**ADDENDUM # 4**

<b>Project</b>	Nelson H.S. Renovations	<b>Project No.</b>	2323
<b>Location</b>	4181 New Street, Burlington, Ontario	<b>Date of Issue</b>	2024 06 04
<b>Owner</b>	The Halton District School Board	<b>File</b>	2323/7.1.3

# MECHANICAL ADDENDUM M-03

Project Name: HDSB Nelson High School Renovations Date: June 3, 2024  
Project Address: 4181 New Street,  
Burlington, ON L7L 1T3  
Project No.: 23178

## M3.2

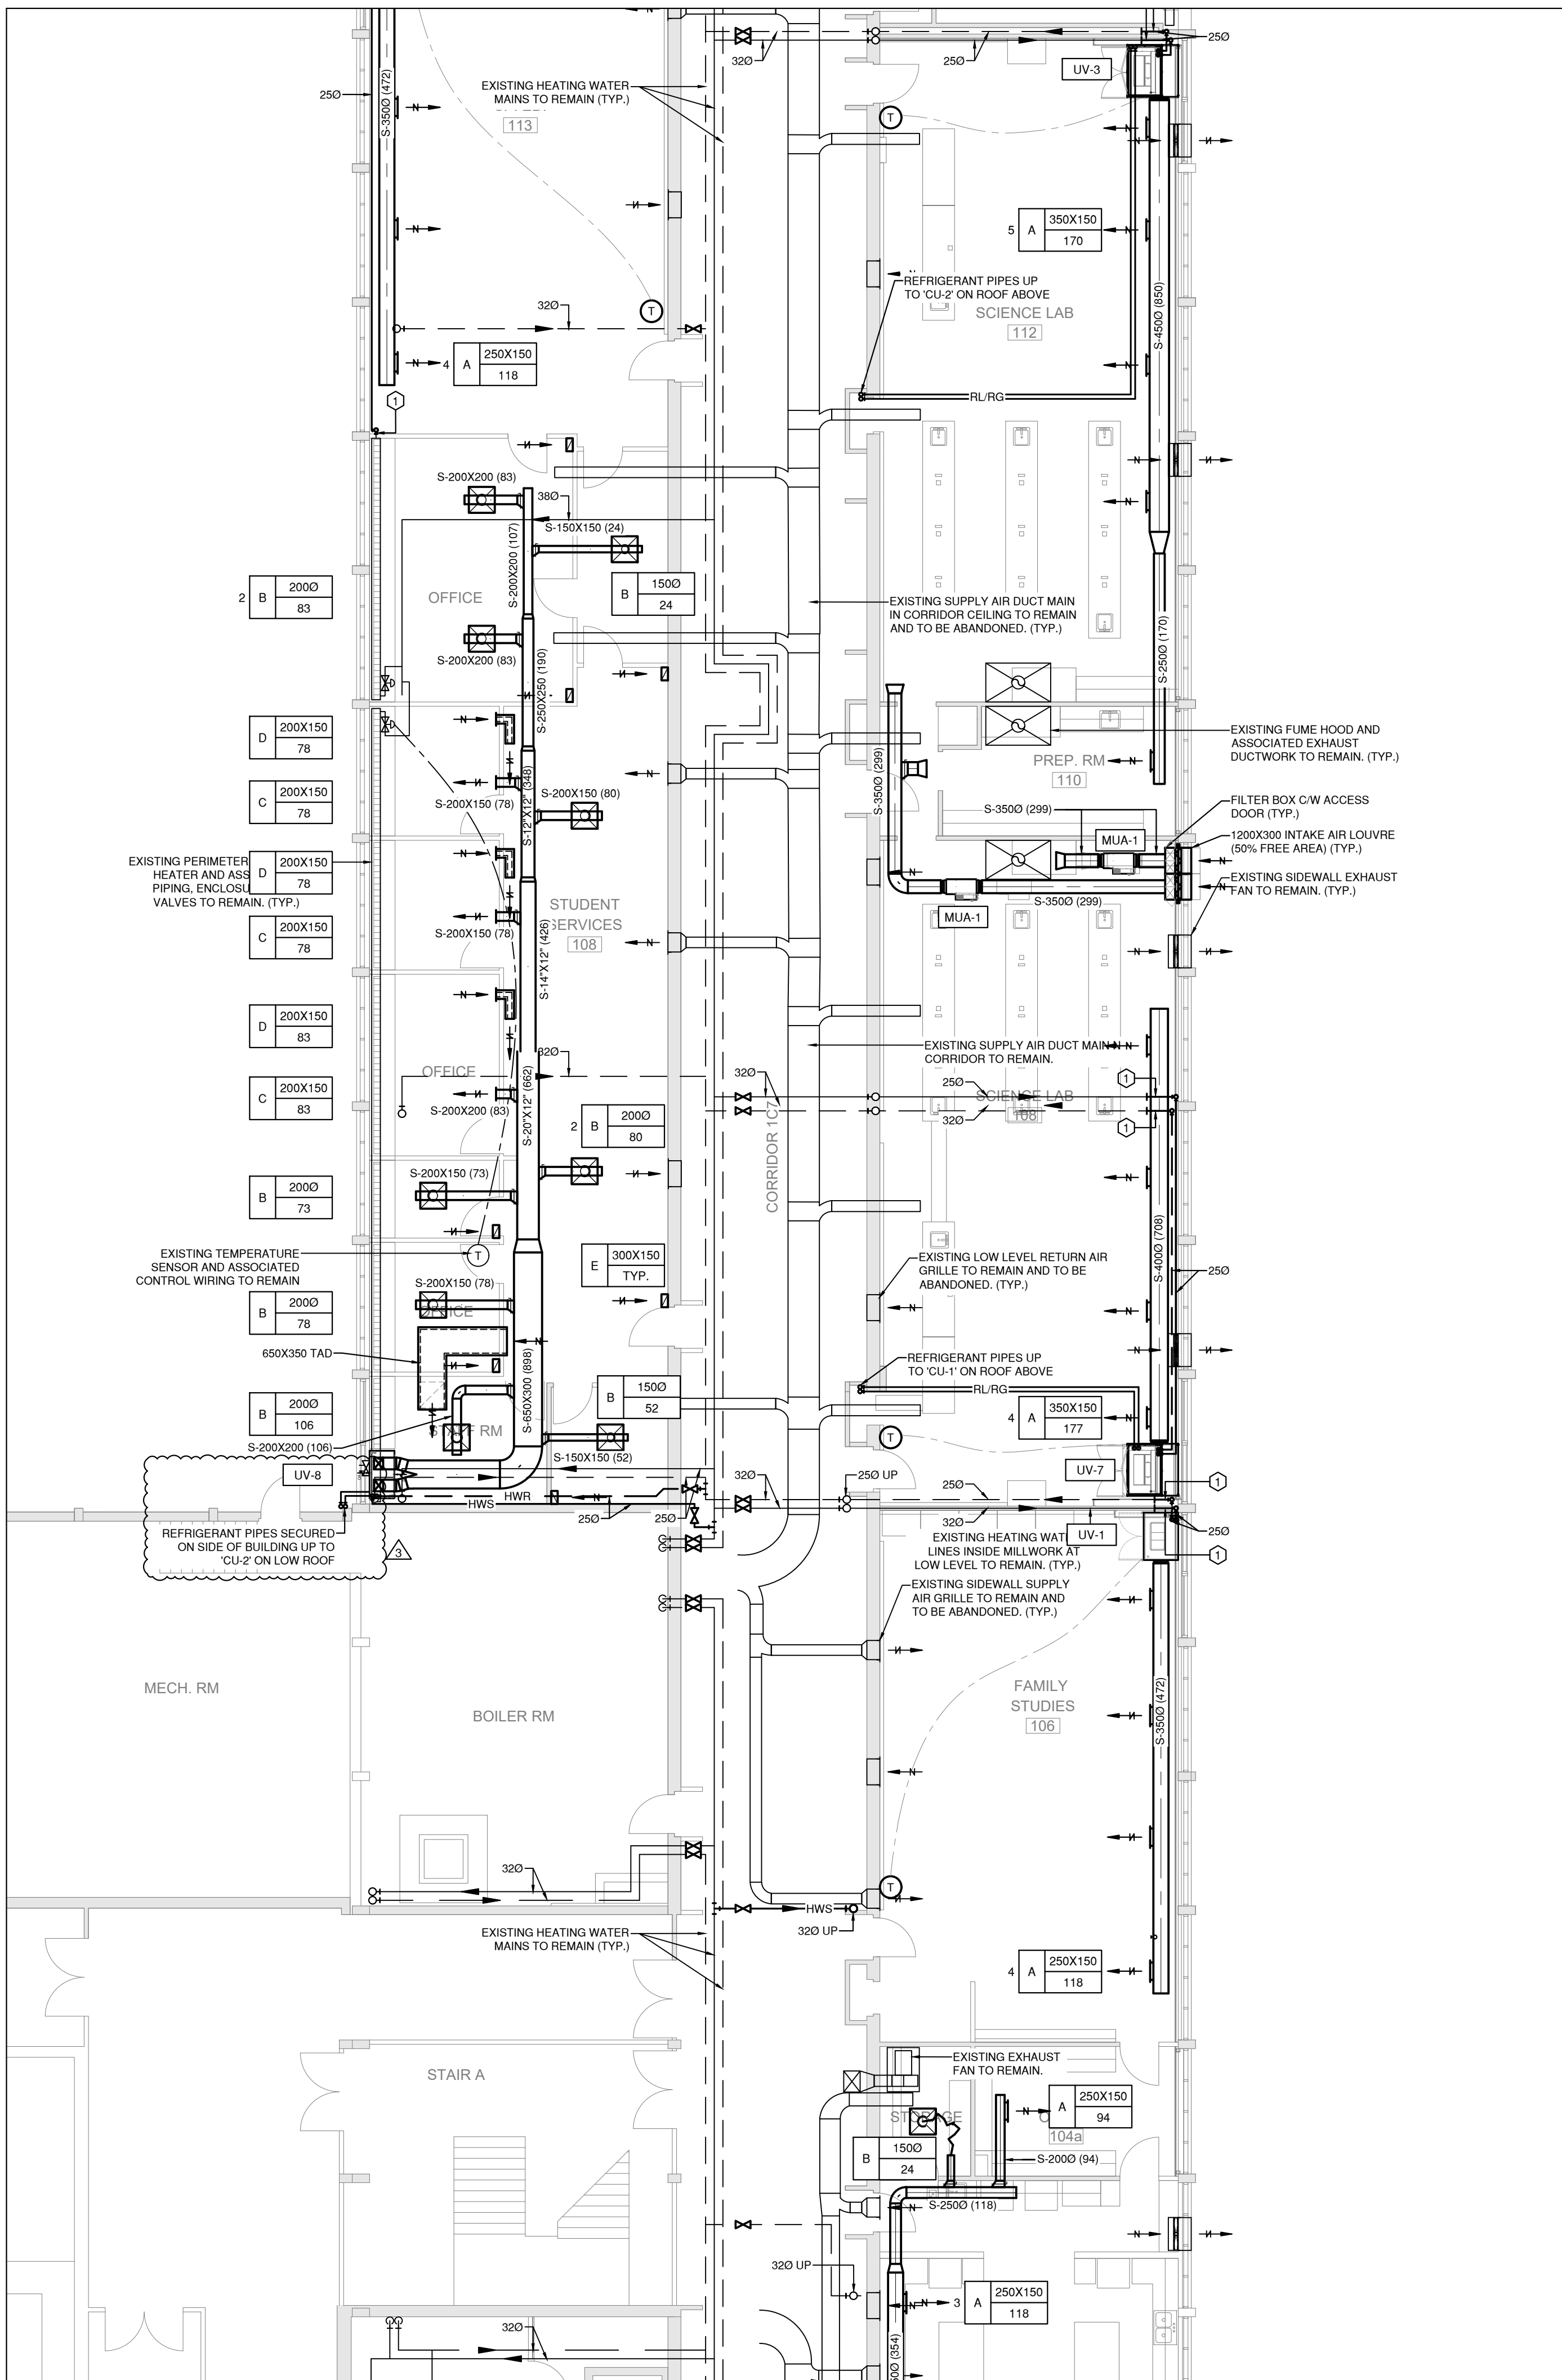
### 2.1. M-3.2: PARTIAL GROUND FLOOR NEW WORK PLAN - HVAC

- .1 Route refrigerant lines for 'UV-8' as indicated. Secure pipes to side of building up to low roof.
